# **BUTTE REGIONAL TRANSIT OPERATIONS CENTER**

Tenant Improvement

## **ADDENDUM NO. 3**

1/18/2016

JOB NO. 5006A3	SHEET <b>A100</b>
DATE 12/3/15

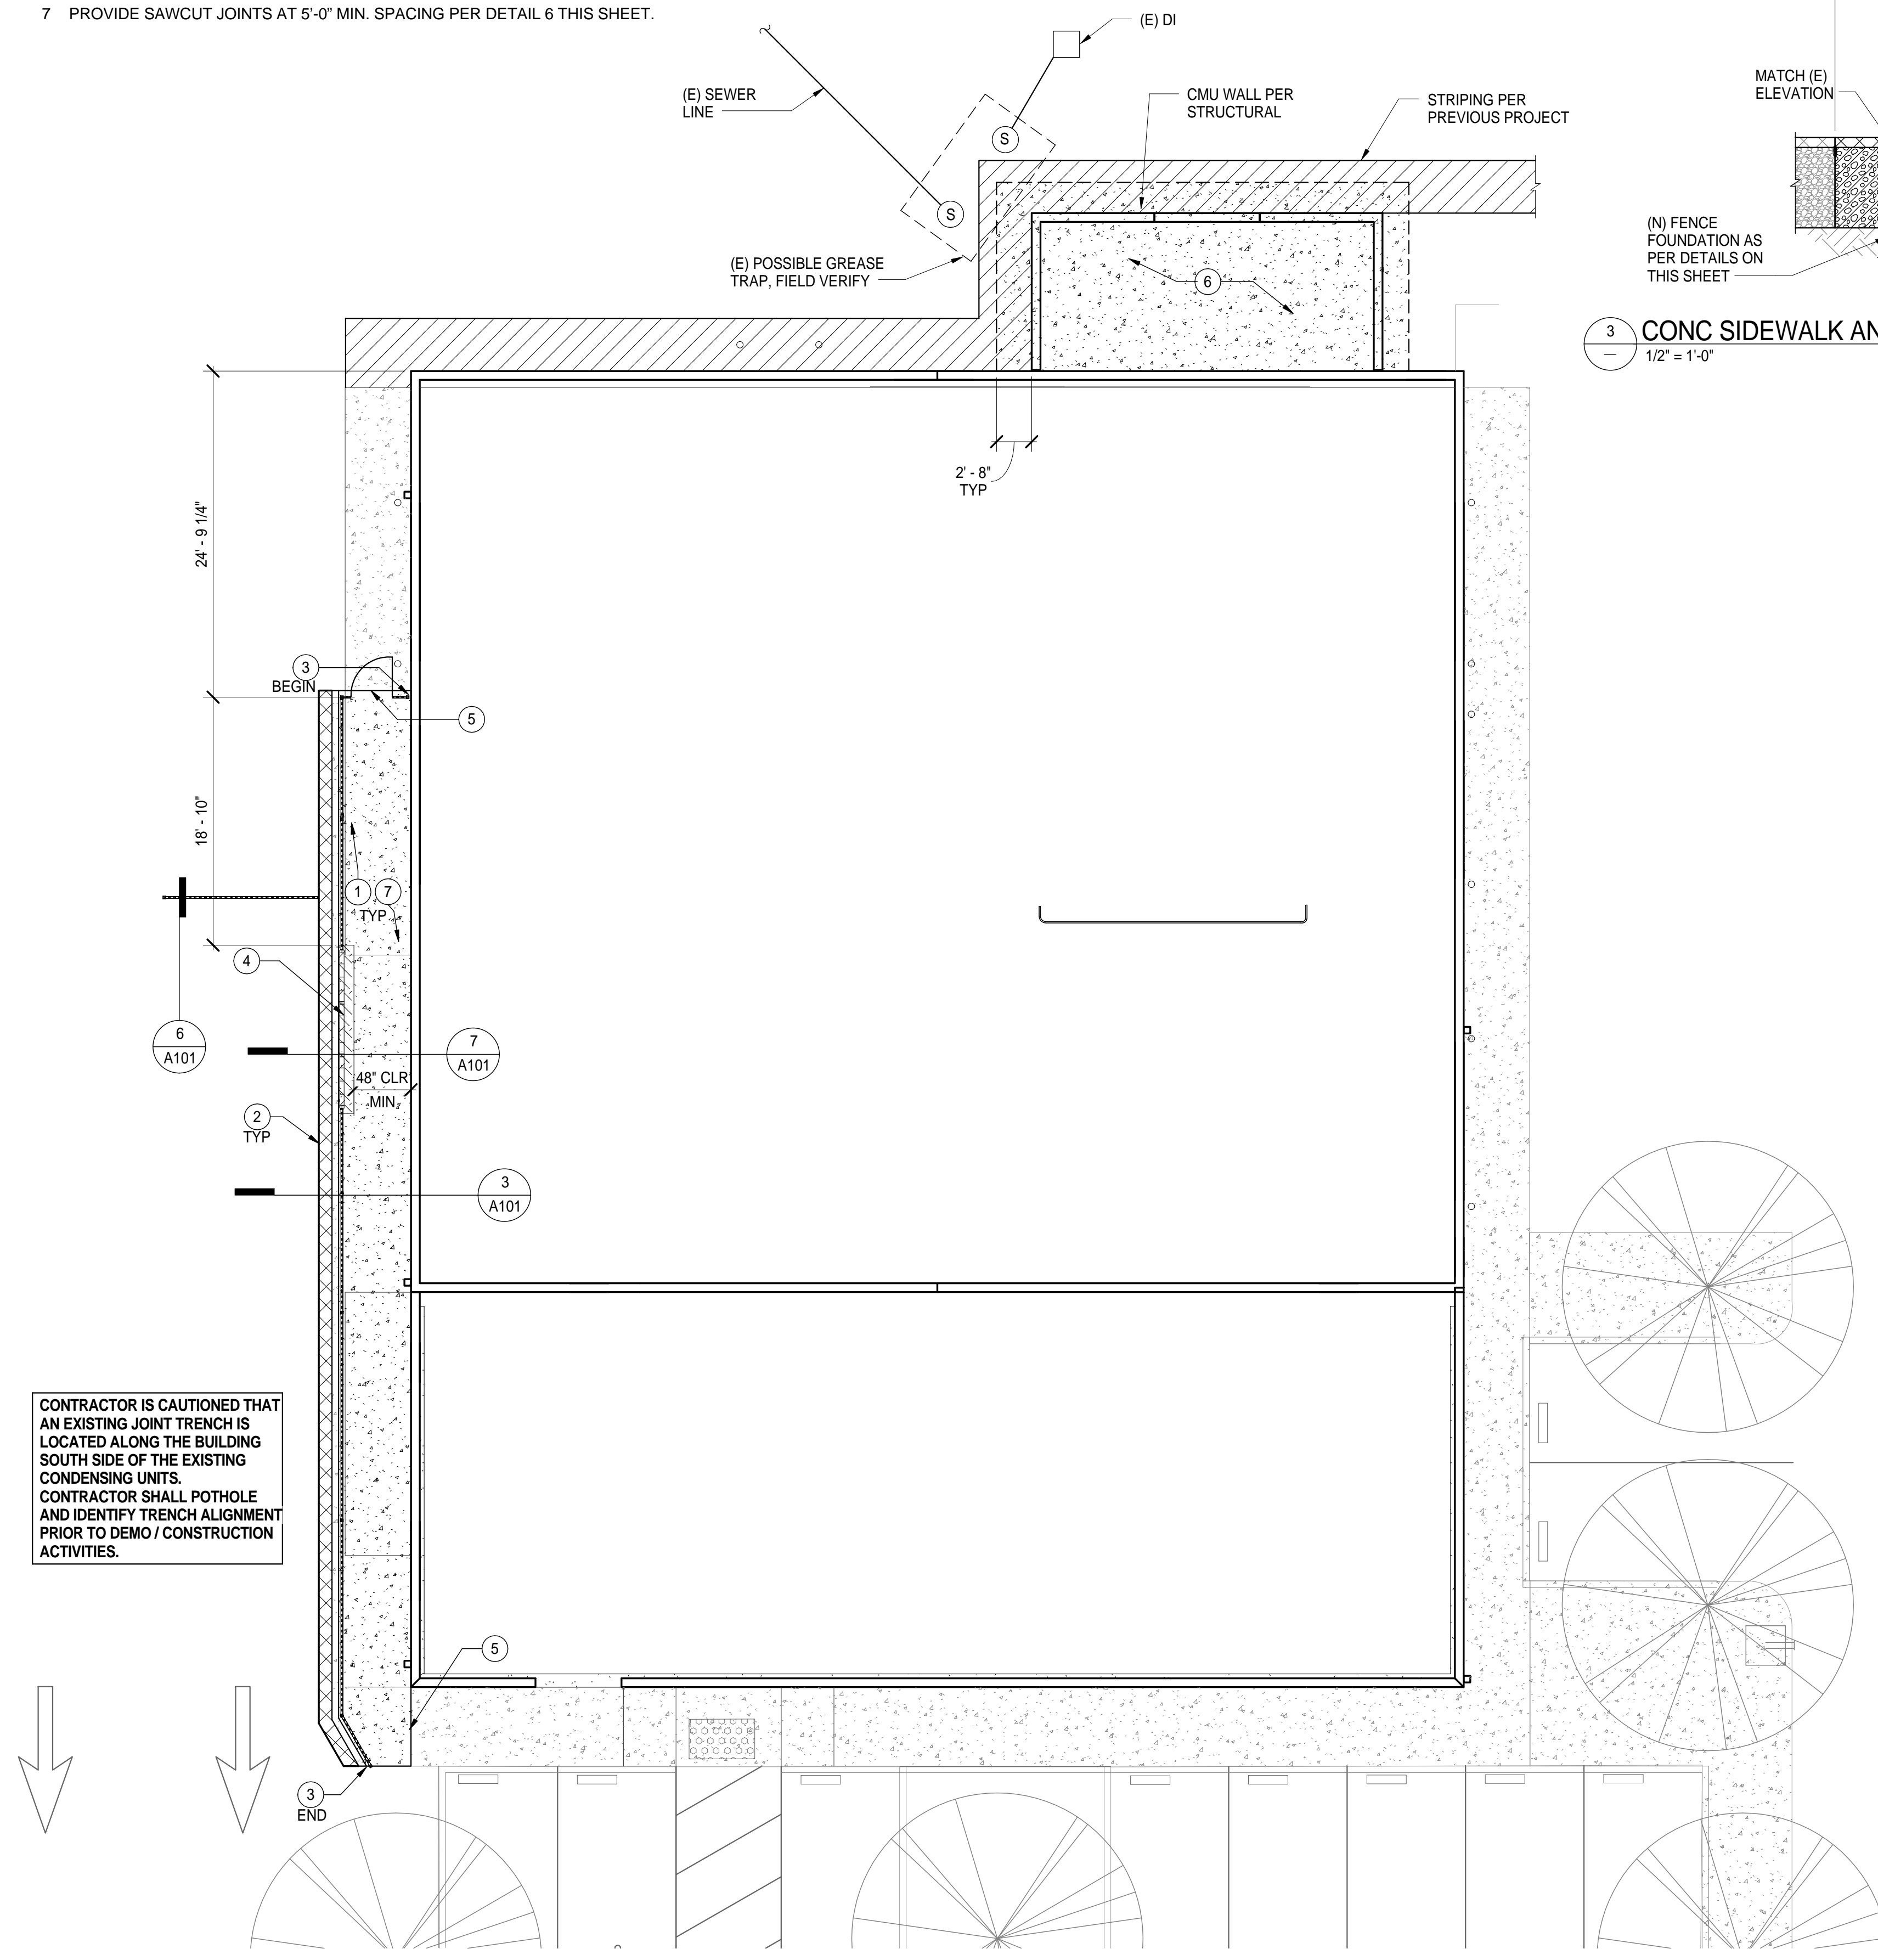
- 1.1 REVISION TO DRAWING G001 – COVER SHEET
  - a. Bid Alternate reference added
- 1.2 REVISION TO DRAWING A100 – ARCHITECTURAL SITE PLAN
  - a. Bid Alternate - Information added to direct contractor to provide pricing for trenching a gas line as shown and the installation of (2) bollards.
- 1.3 REVISION TO DRAWING AD201 – DEMO FLOOR PLAN
  - a. Bid Alternate added to remove the existing gas meter on the south elevation per keynote 34.

**AD201**

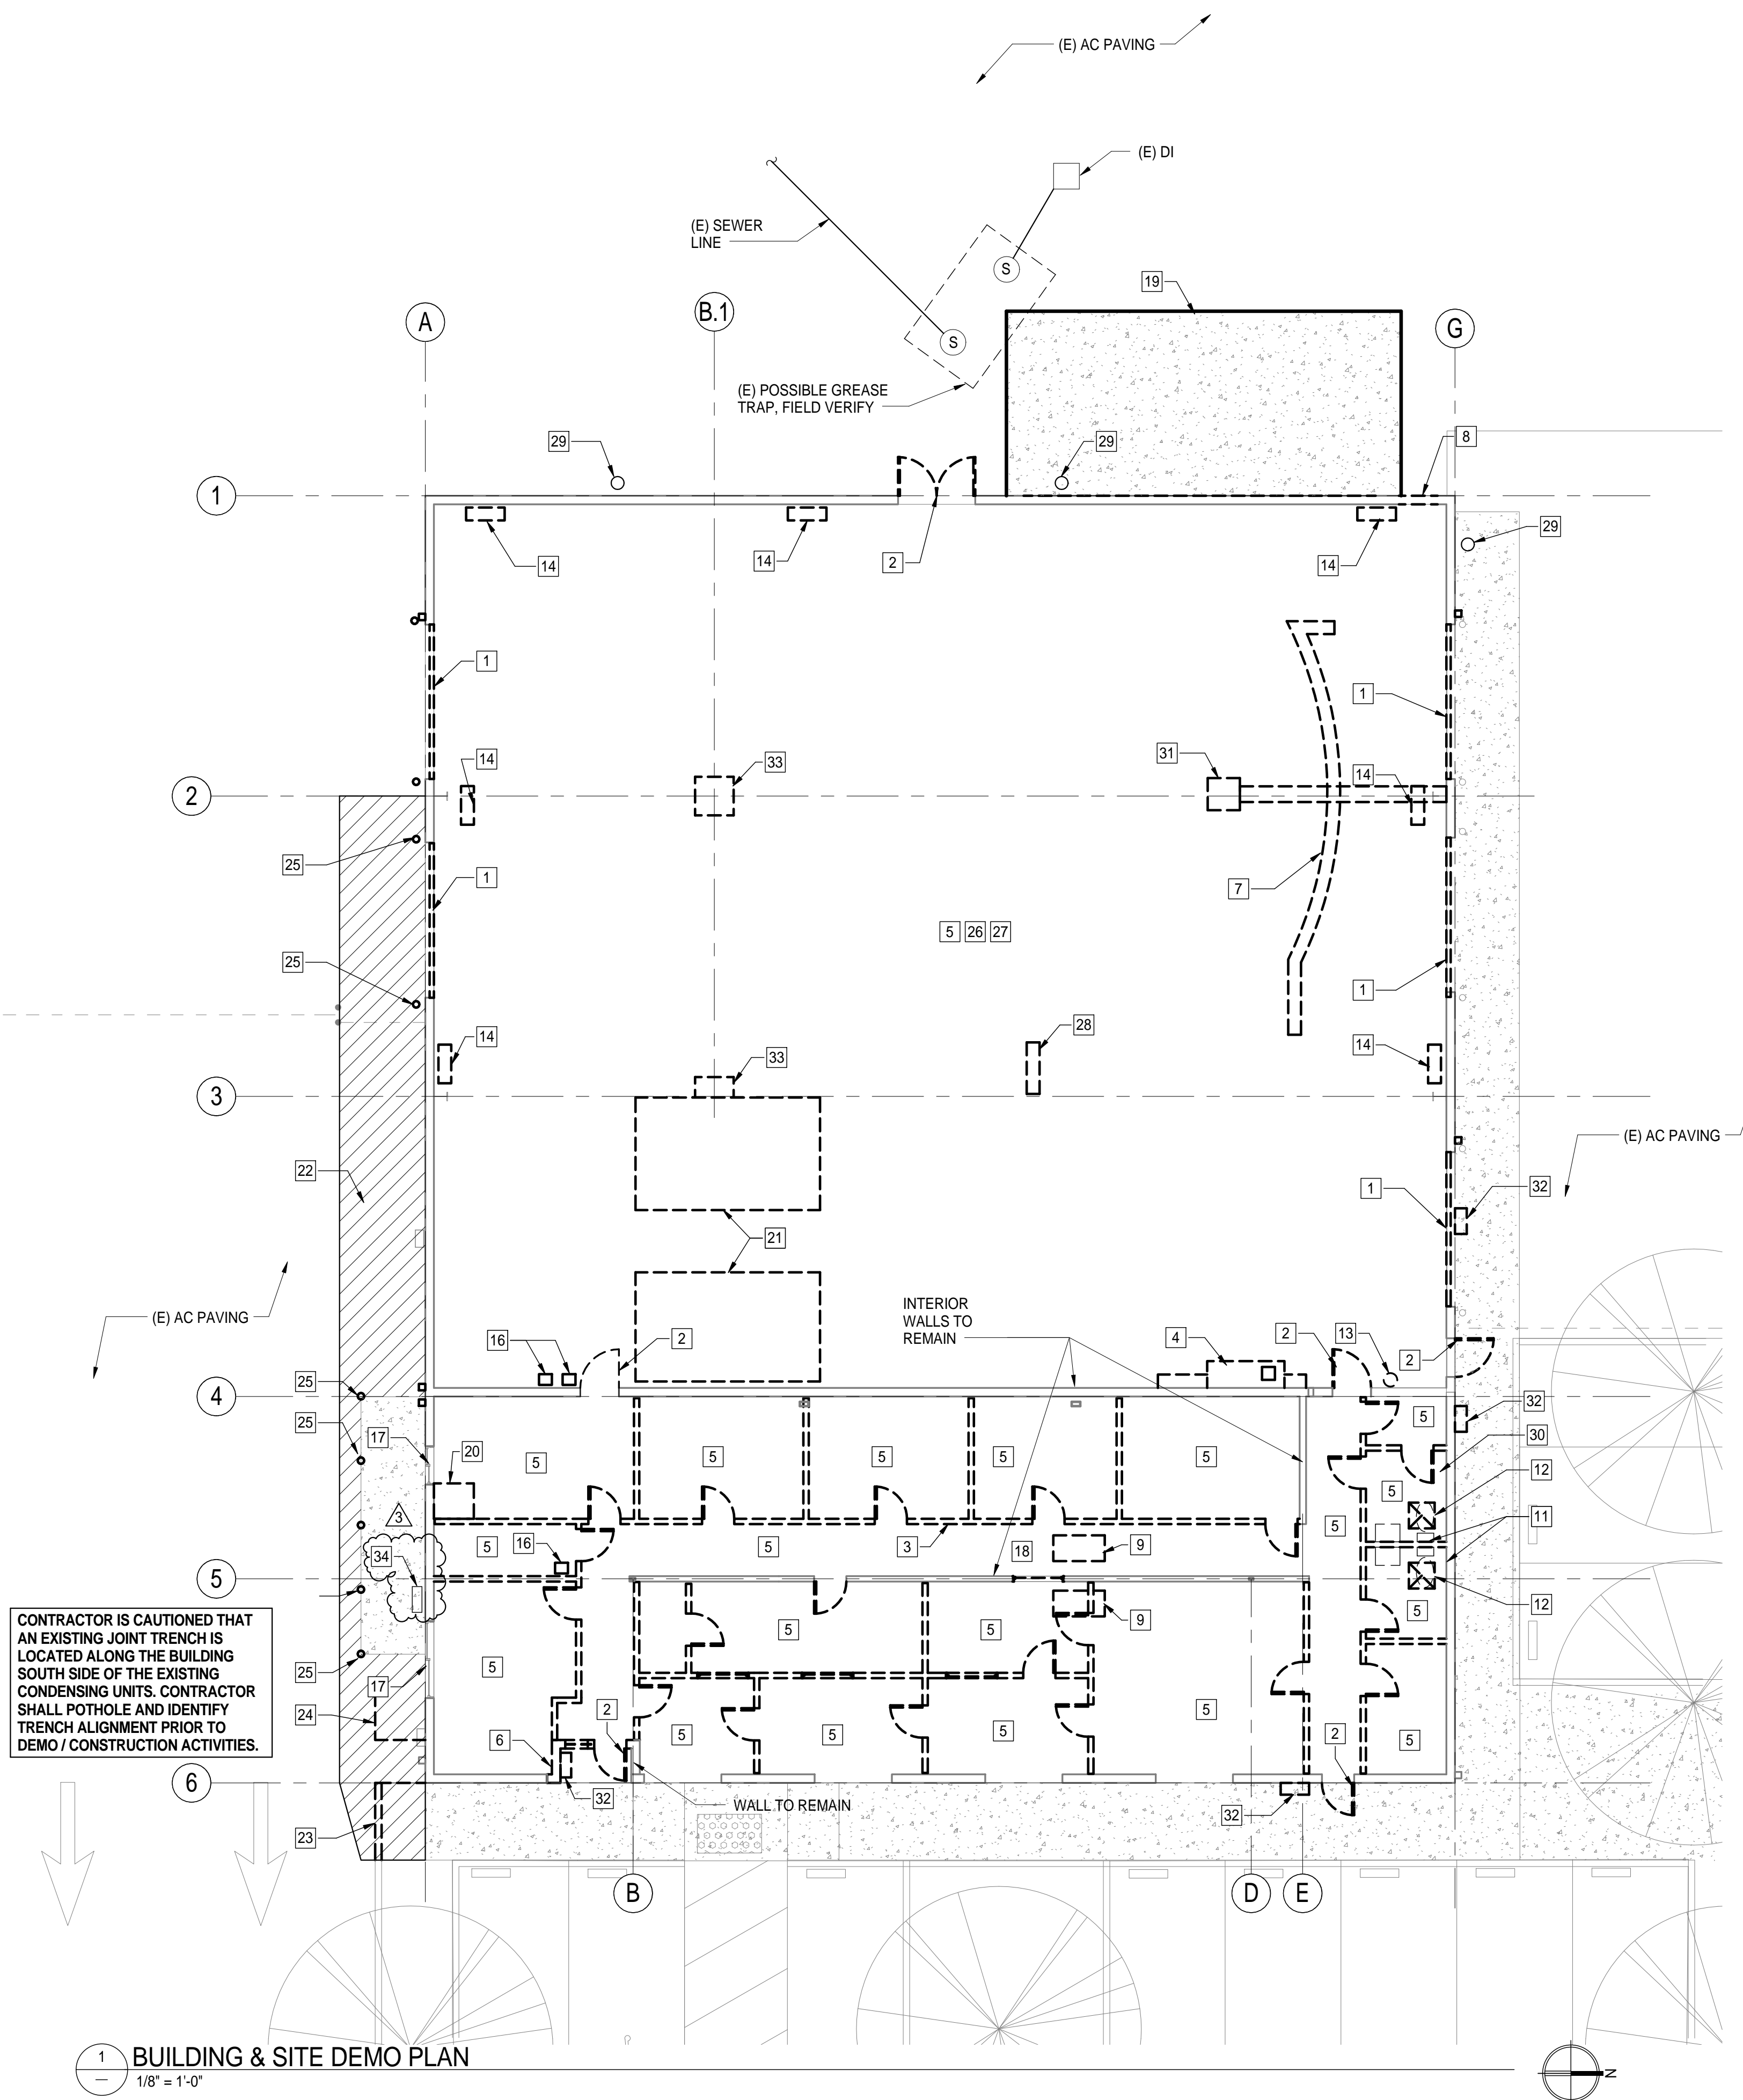
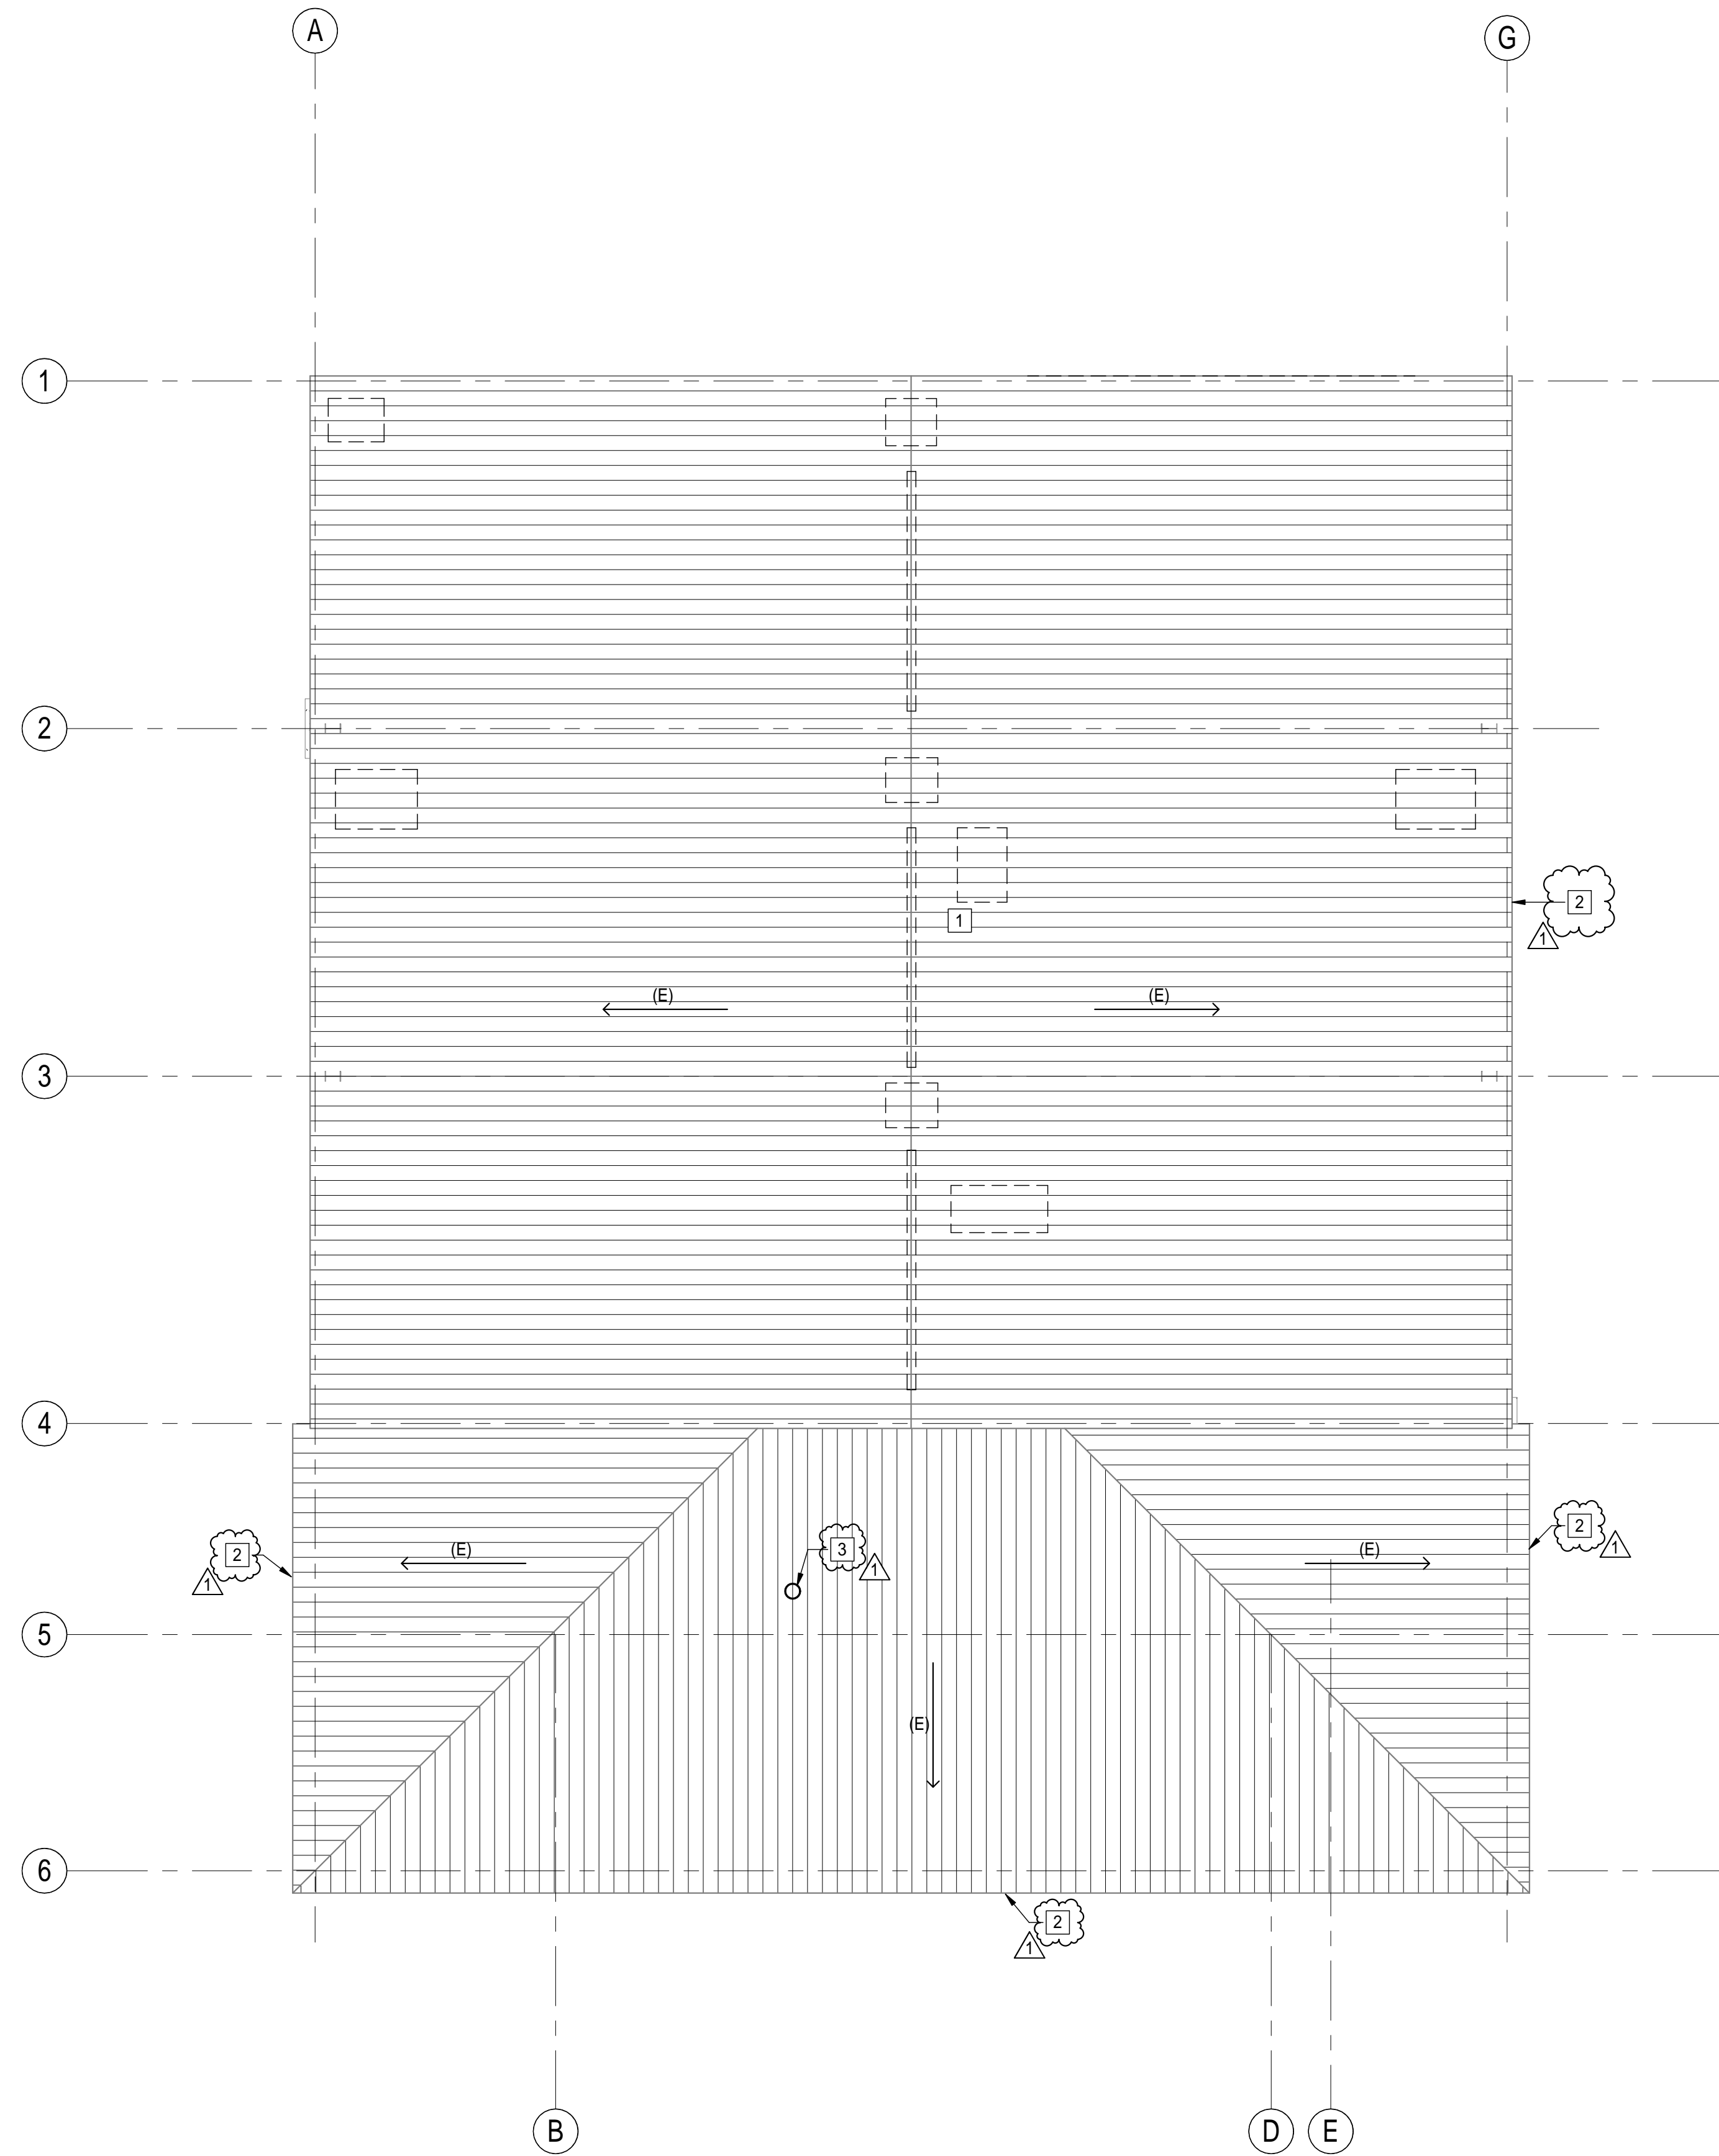
- (E) EXTERIOR LIGHTS TO BE DEMOLISHED.
- DEMO SLAB AS REQUIRED FOR COLUMN FOOTING. SEE STRUCTURAL DRAWINGS.
- ▲ (BID ALTERNATE) CONTRACTOR TO PROVIDE A PRICE TO REMOVE (E) GAS METER, CAP/ABANDON PIPING AS NECESSARY AND REPAIR BUILDING EXTERIOR FINISH AS APPROPRIATE. GC TO COORDINATE W/ LOCAL UTILITY.
